**City of Evansville Plan Commission**  
Regular Meeting  
City Hall, 31 S Madison St., Evansville, WI 53536  
Tuesday, September 3rd, 2024, 6:00 pm

PRELIMINARY PLAT OF  
**SETTLER'S GROVE SUBDIVISION**

Re: Settler's Grove Preliminary Plat Comments

# SETTLER'S GROVE SUBDIVISION

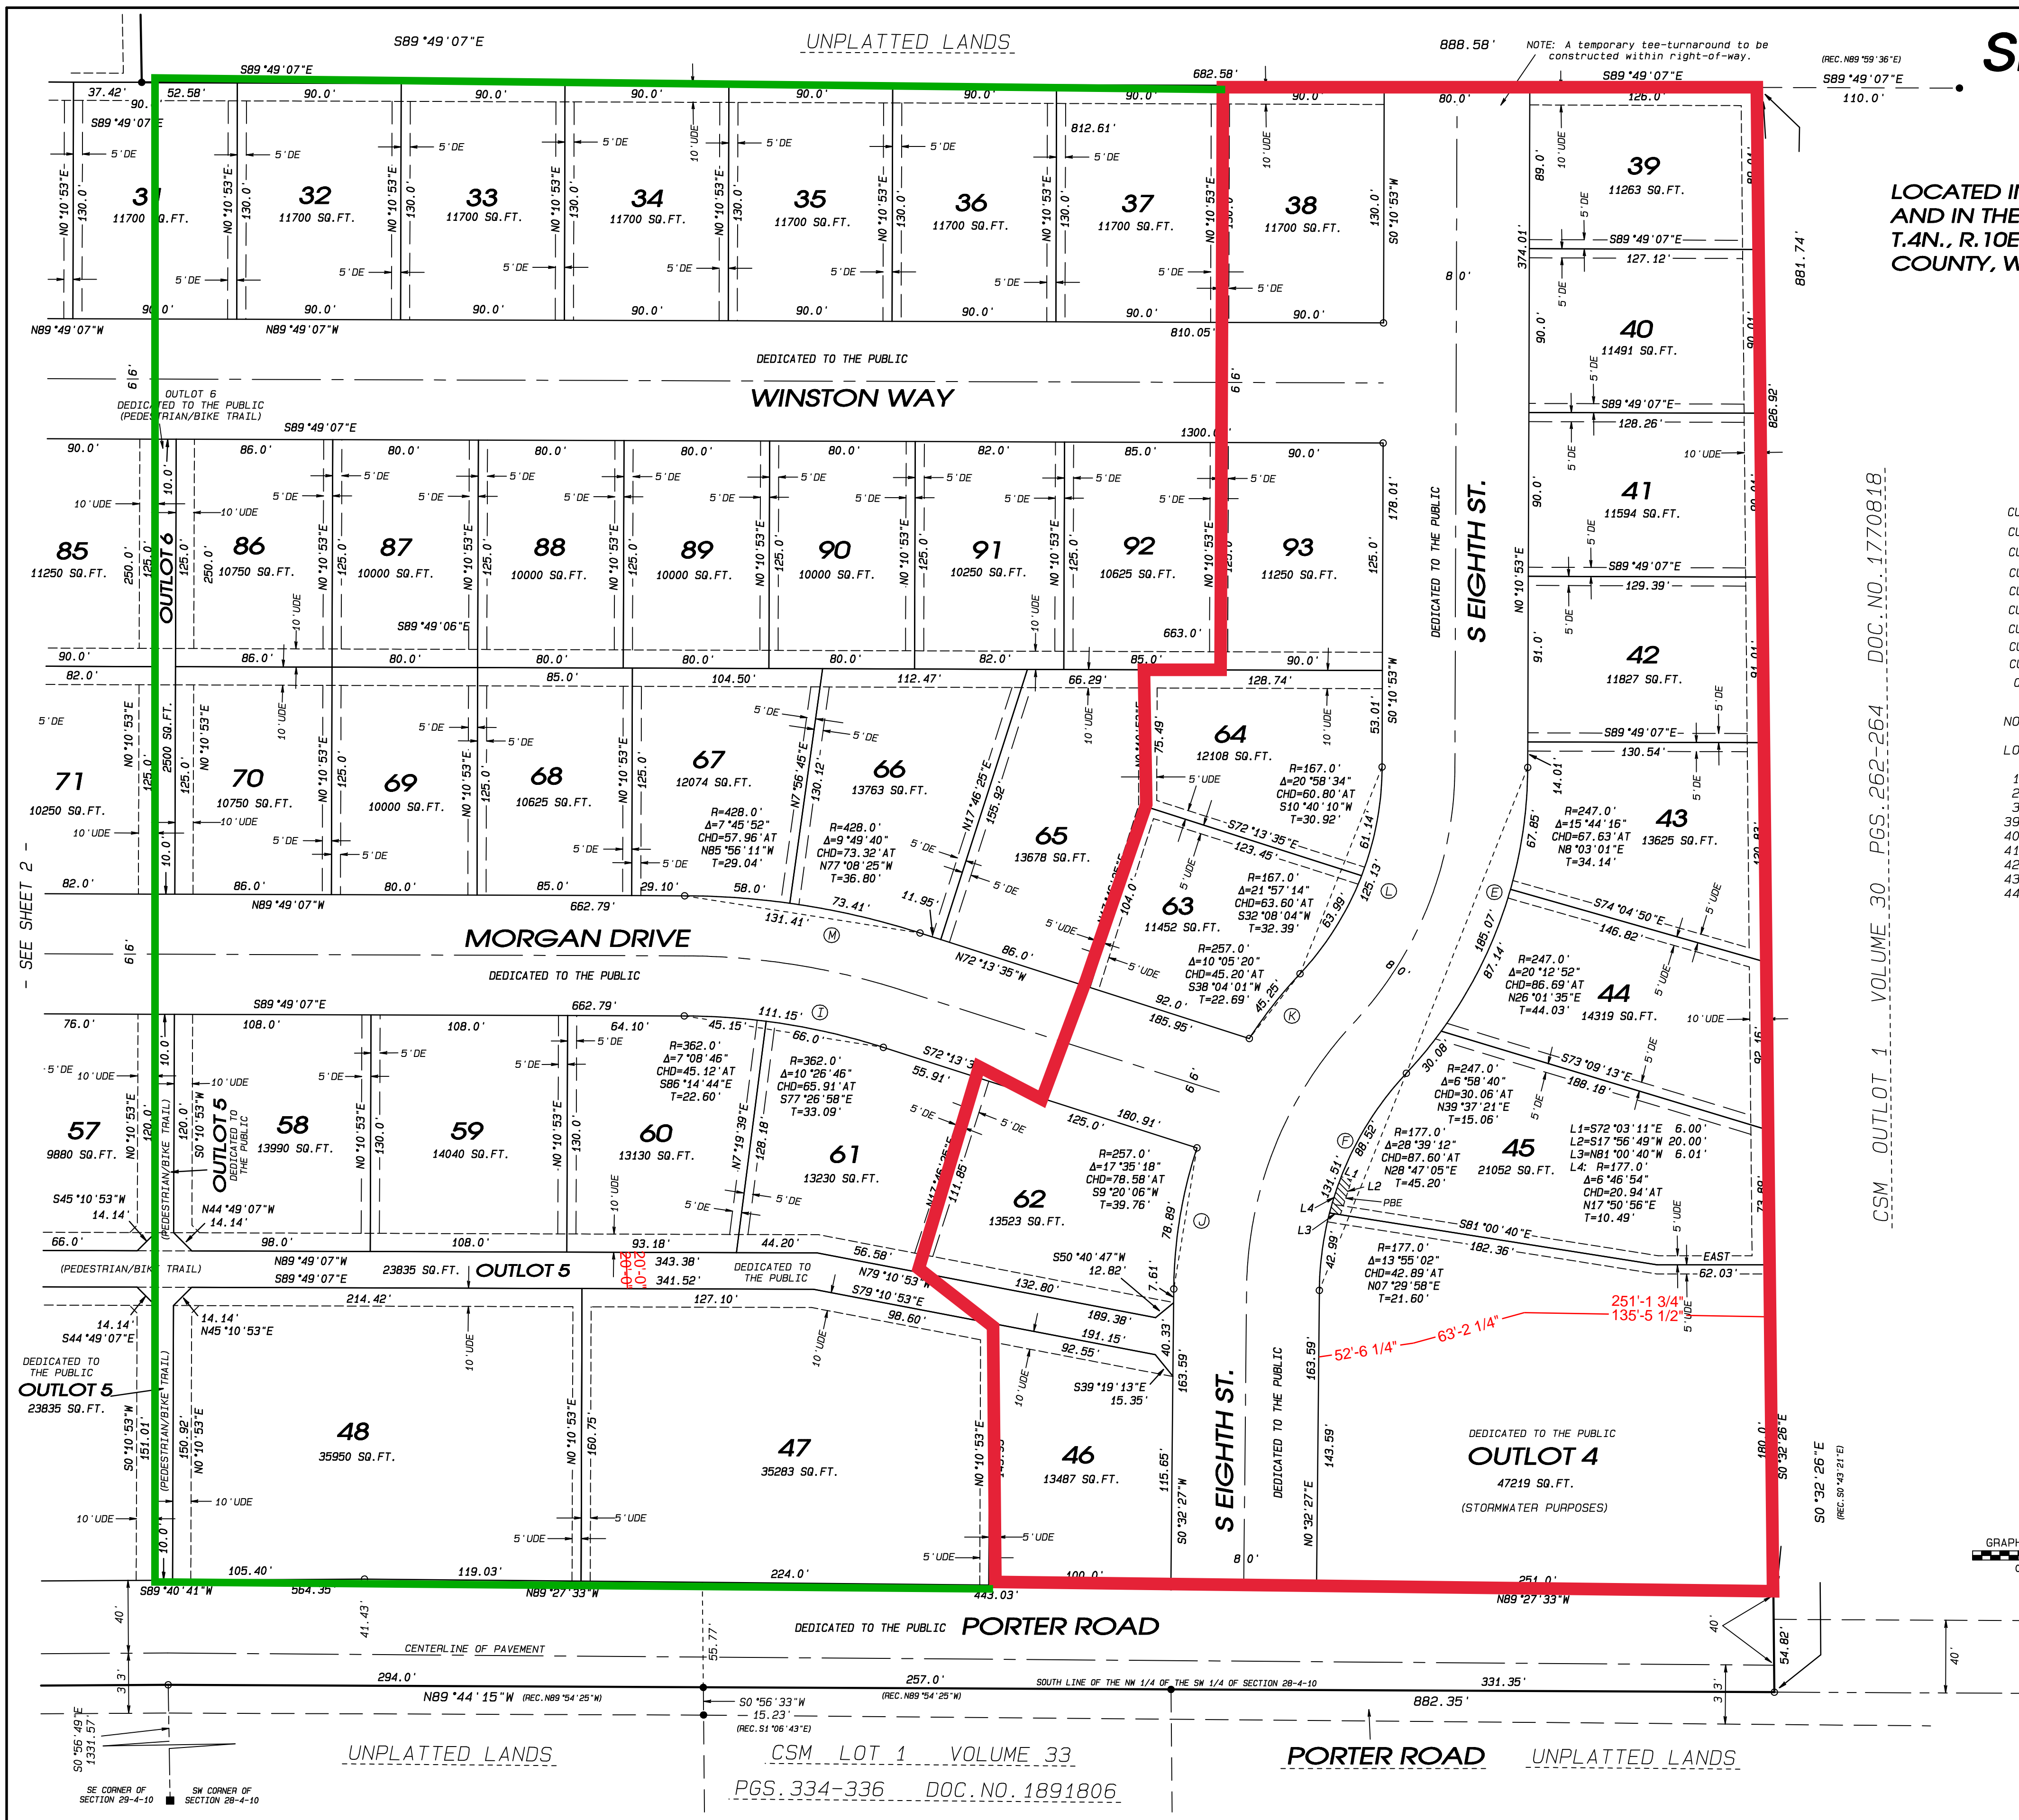
- Remove the proposed median and sign on South Eighth Street at its intersection with Porter Road.
- An 80' right-of-way is not strictly necessary for South Eighth Street. 66' feet would be allowed for this road, which is shown as a local road on the Future Land Use map. Shortening the road may help the profit margin of this project by reducing the amount of pavement needed.

- Text in Outlot 1 reads that the land has already been rezoned to the R-2 zoning district. This is not true; a separate rezoning application will be required for the entire parcel. (This is another reason staff recommend platting the entirety of the parcel now; rezoning new lots will ensure that future density goals can be met.

- The recreational trail runs very close to grade of the proposed stormwater pond. Staff would like to see at least five feet of at-grade separation between the trail and the pond. Outlot 1 should be enlarged to the north to shift the path in order to minimize potential conflict.

- Another outlot, or a northern extension of Outlot 1 that is at least 20' wide, should be added to the eastern boundary of the plat behind Lots 1 through 7. This area will be dedicated to the public for a multiuse path. The City does not intend to adjust the grading of the stormwater basin, so an outlot on this parcel is necessary.

- Lot 1 exceeds the maximum area and lot width allowed for the R-2 zoning district. Options to rectify this include adjusting lot areas along that side of Eighth Street or zoning the lot for townhouse/multifamily use.

- Lot 2 also exceeds the maximum lot area allowed for the R-2 zoning district, but this should be fixed with the suggested changes to Outlot 1.
- Developer suggests a duplex on Lot 13. Driveways for both units would be close together due to utility/drainage easements and have the potential to conflict with the recreational trail. Staff suggest either a single family unit or a making Lot 13 part of a larger multifamily lot.

- Correct spelling of street name – "S. Eighth Street" versus "S. Eight Street"
- Lot 10 is listed as having a front lot line of 69'. It should be 96'.

- Concept plan that shows how the entire parcel will yield at least 3.66 housing units per acres at build out.
- Complete preliminary plat, showing extension of road rights-of-way to the edge of the tract and adjustments to Outlot 1 for multiuse paths.
